Attachment to  
ULNRC-06754  
July 5, 2022

**Ameren Missouri Response to NRC RAIs**

### Ameren Missouri Response to NRC RAIs

On September 28, 2021 Union Electric Company, dba Ameren Missouri, submitted a license amendment request (LAR) for Callaway Plant, Unit No. 1 (Callaway) to the U.S. Nuclear Regulatory Commission (NRC). Pursuant to Title 10 of *Code of Federal Regulations* (10 CFR) Section 50.90, "Application for amendment of license, construction permit, or early site permit," and 10 CFR 50.67, "Accident Source Term," the licensee requested, in part, to incorporate the alternative source term (AST) dose analysis methodology into the Callaway licensing basis. As the U.S. Nuclear Regulatory Commission (NRC) staff is continuing to review the application, it recently determined that additional information is required in order to complete the review of the subject LAR. The NRC staff's request for additional information (RAI), consisting of four individual requests, RAI No. 1 (with four parts), RAI No. 2 (with three parts), RAI No. 3, and RAI No. 4 (with three parts), was electronically transmitted on June 2, 2022.

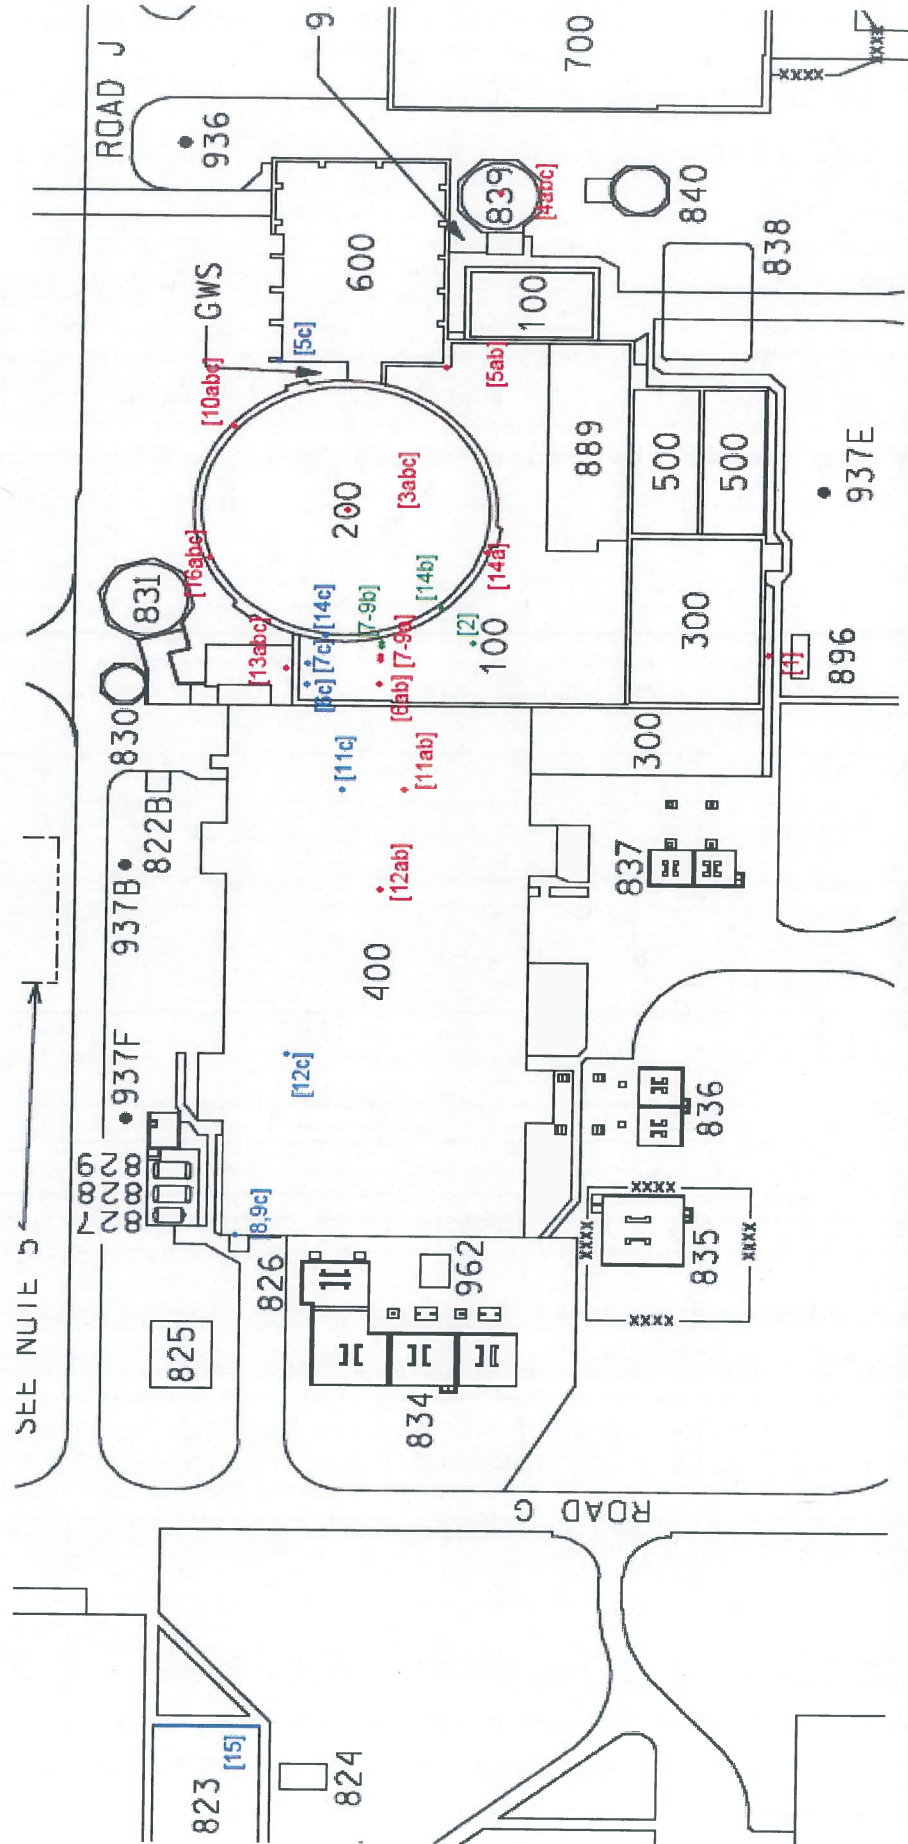
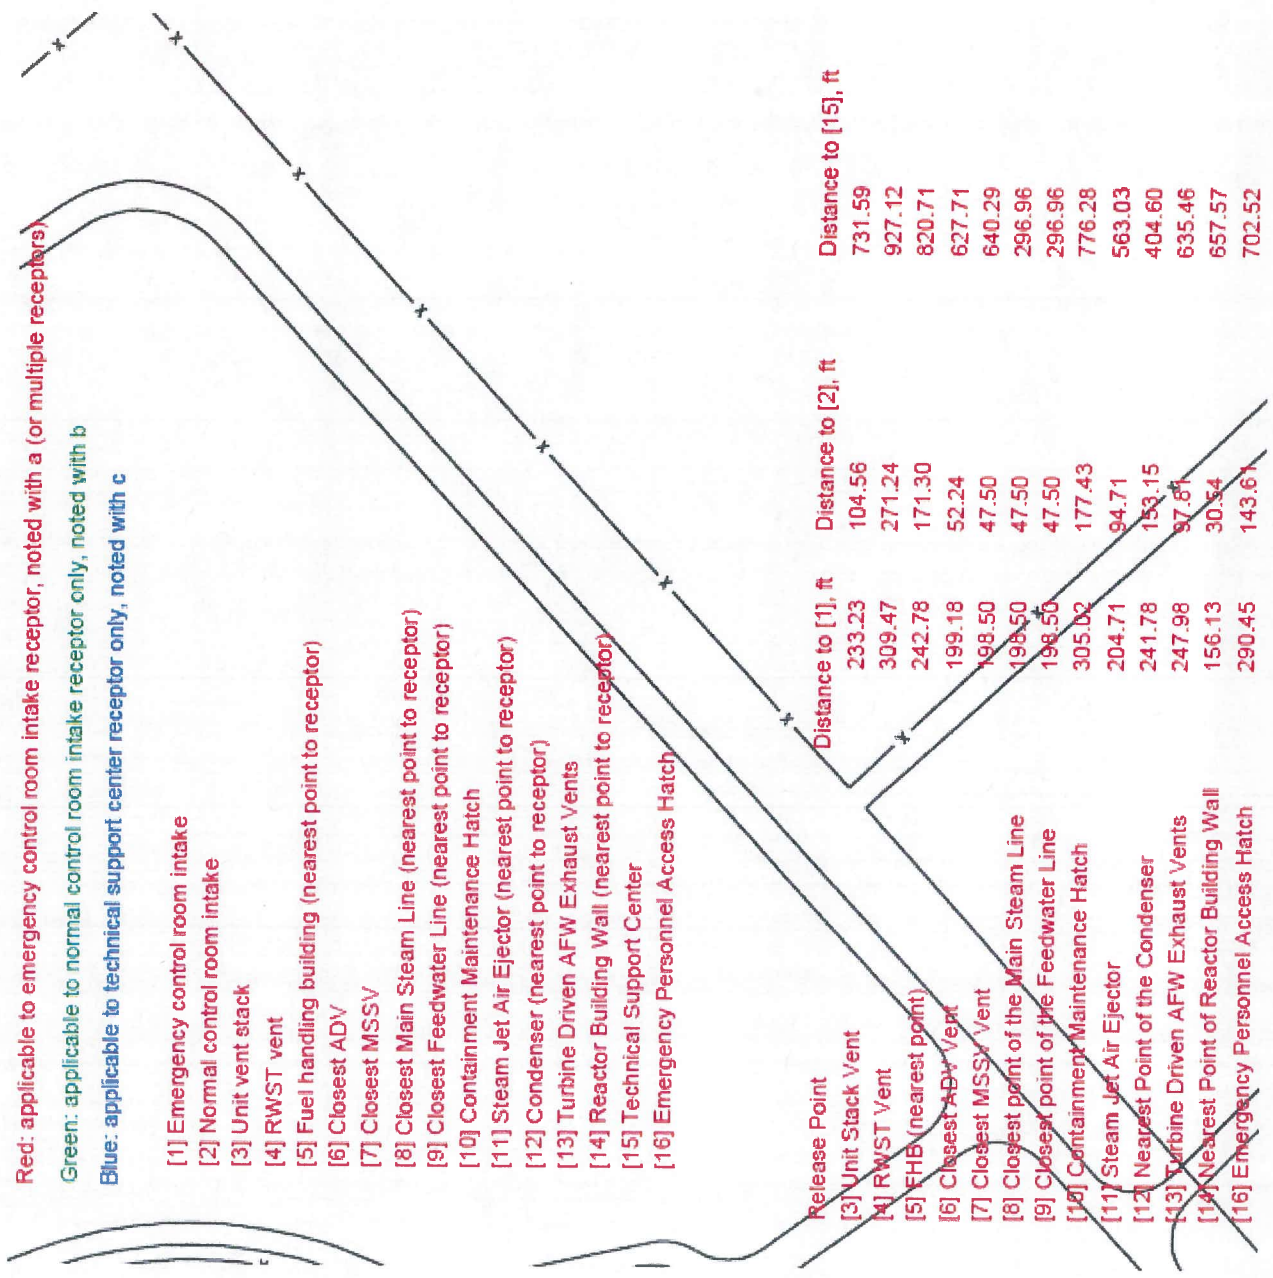
- a) The NRC staff tried to verify many of the distances between the numerous potential source and receptor pairs as well as the receptor-to-source directions of these pairs relative to True North using Table 3-25 and Figure 3.1 of Enclosure 1 to the supplementary submittal and other readily available information. In doing so, the staff exercised reasonable flexibility, given this information, by considering distances to be verified if they were within about  $\pm 5$  meters and about  $\pm 5$  degrees relative to True North of the values listed in Table 3-25.

The items listed in Figure 3.1 use phrases such as “nearest point to receptor”, “closest [source name]”, and “closest [source name] nearest point to receptor”. However, when evaluating a number of the same sources but impacting a different receptor, the distance and/or receptor-to-source direction would only meet the above acceptance criteria if the source and/or receptor were located in different positions (e.g., at some point on the item label itself, at the tip of the arrow associated with an item label, at some point on the edge of the building housing a potential source or receptor, or at some point within the perimeter of the building itself).

As a result, this portion of the ARCON96-NAI dispersion modeling review was not completed. Because these characteristics are direct inputs to the run files, Figure 3.1 in Enclosure 1 of the supplemental submittal should be clarified: (a) to include a distance

scale, and (b) show specific source and receptor locations that correspond to the various model runs. Due to the number of model-runs, more than one figure may be necessary to clearly illustrate all of these relationships. Any other figures, tables, and text affected by these clarifications should be revised as well.

- a) Excerpts of the plant area layout with the attached digital markup, drawing 8600-X-88100 are included below and the measured distances and angles between release and receptor locations. The drawing scale, highlighted in yellow, was used to determine all distances associated with the release/receptor pairings of the PAVAN and ARCON model runs. The release and receptor locations are indicated with color-coded alphanumeric values. Release points are given a strictly numerical value, while receptor locations are assigned one or more letters between 'a' and 'c' indicating the associated release point(s). Red alphanumeric values are applicable to the emergency Control Room intake receptor at minimum. Green alphanumeric values are applicable to the normal Control Room intake receptor only. Blue alphanumeric values are applicable to the Technical Support Center (TSC) receptor only.

\*Scale applies to native digital drawing only.

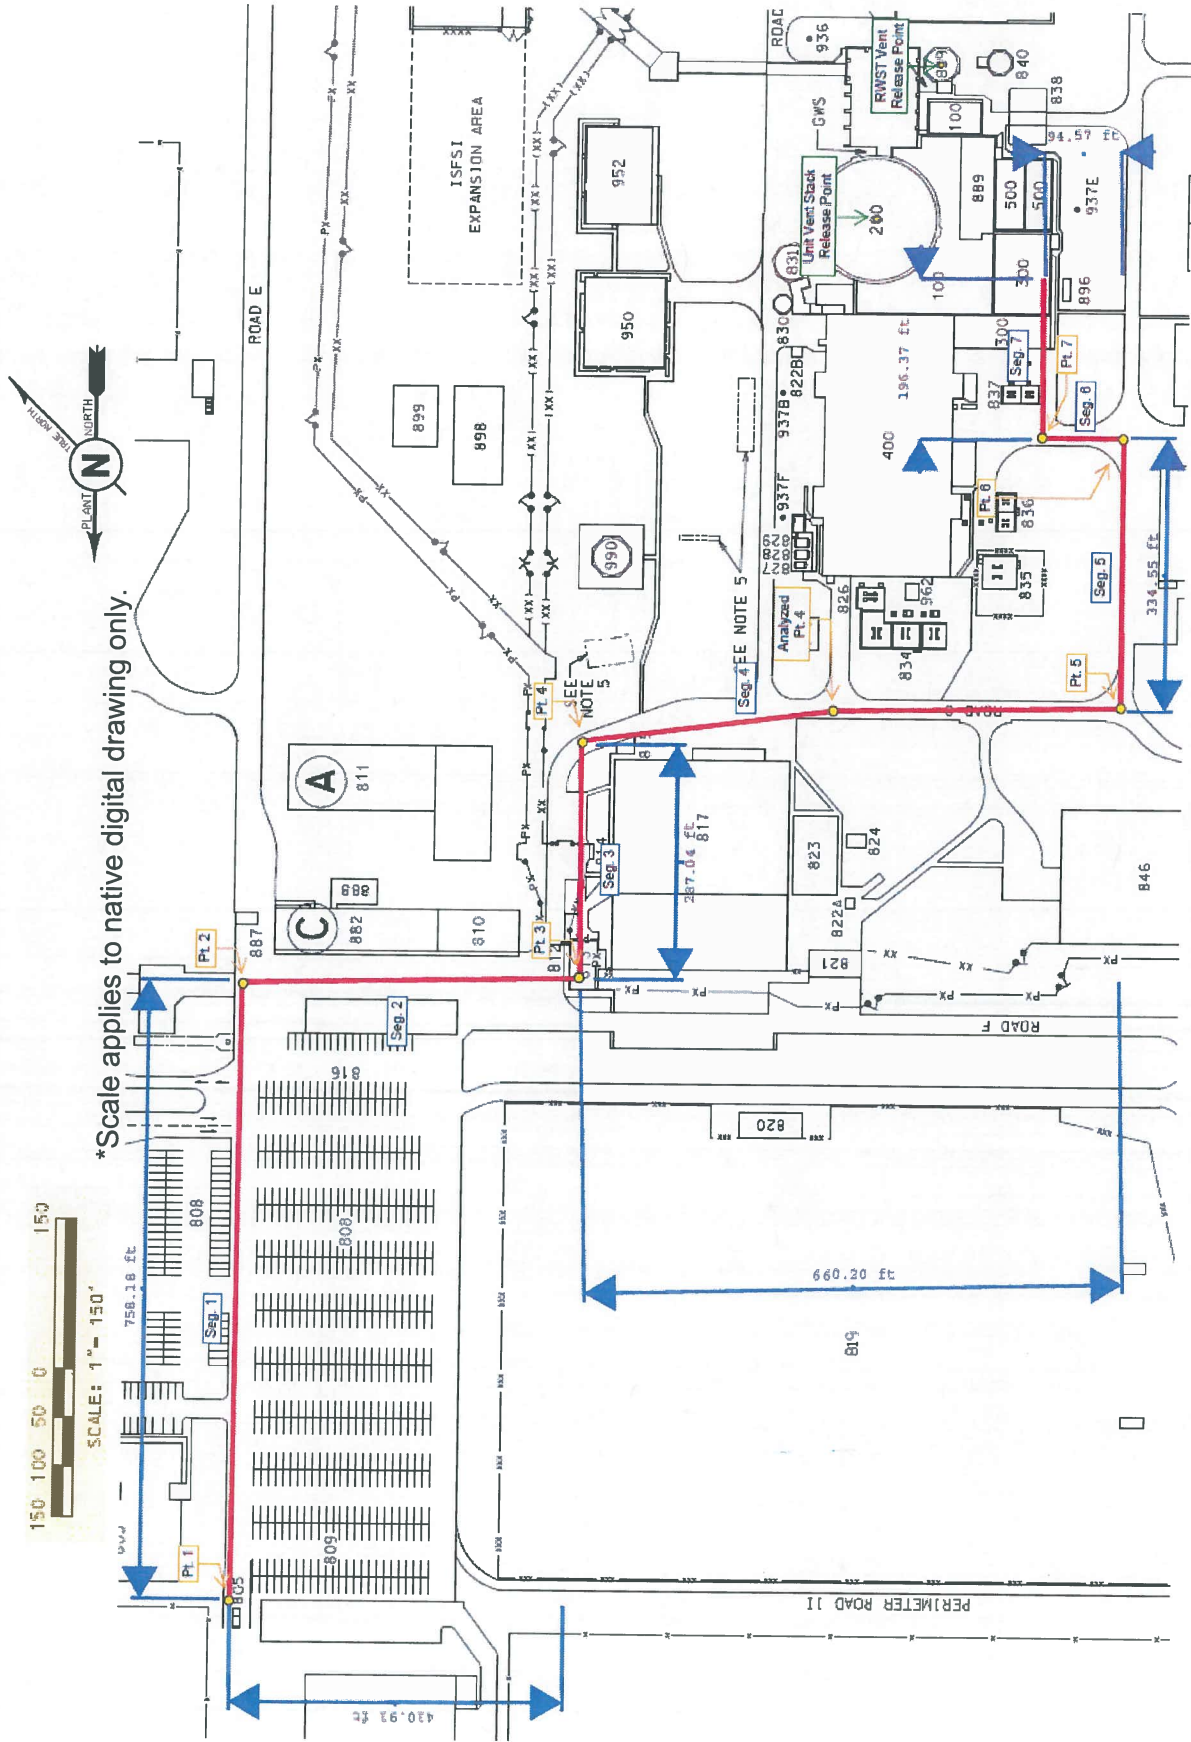
- b) Figure 3.2 in Enclosure 1 of the supplemental submittal should be: (a) clarified to include a distance scale, (b) ensure that its orientation, as reproduced in that submittal, is relative to Plant North, (c) identify the potential release points for the reactor building vent and RWST vent, and (d) indicate the receptor locations evaluated in the corresponding model runs (e.g., presumably at the turning points along the sketched path in Figure 3.2). As above, any other figures, tables, and text affected by these clarifications should be revised as well.

- b) Excerpts of the plant area layout, drawing 8600-X-88100 are included below. The drawing scale, highlighted in yellow, and compass were used to determine all distances and angles associated with the release/receptor pairings of the ARCON96 model runs. The path taken by the operator during CR ingress/egress is depicted with a red line from the parking lot to the Control Building. Turning points in the operator's path (labeled with yellow boxes) were used to divide the trip into seven segments (labeled with blue boxes). The length of each segment was scaled from the drawing. The determined measurement of each segment is indicated with two straight blue lines, a set of blue arrows to indicate the direction of the measurement and the length in black text. The measured length of each segment was conservatively rounded up to the next nearest foot. In general, these distances closely matched the result from the root-mean-square of the plant N-S and plant E-W distances; however, to ensure conservatism, the horizontal distance was reduced by 5% for use in ARCON96. The location of analyzed Point 4 is actually at the closest point to containment along Segment 4 for conservatism, as indicated. This point is referred to as Access Point 4 in the License Amendment Request for simplicity.

Segment 1 of the defined path was excluded from the transit dose calculation as operators are expected to park as close to the site entry near Point 3 as possible; however, the segment was included for informational purposes. Segment 2 was retained in full length as a conservative adder to the access dose over and above the projected path operators are expected to take.

The release locations are indicated by green text boxes at the Unit Vent Stack and RWST Vent. A designated release location of the plant stack is applied for the expected diffuse containment leakage with respect to operators in transit at ground level. This release location is conservative as it predicts a higher concentration of radioactive isotopes along the operator path than a diffuse containment leakage model.

\*Scale applies to native digital drawing only.
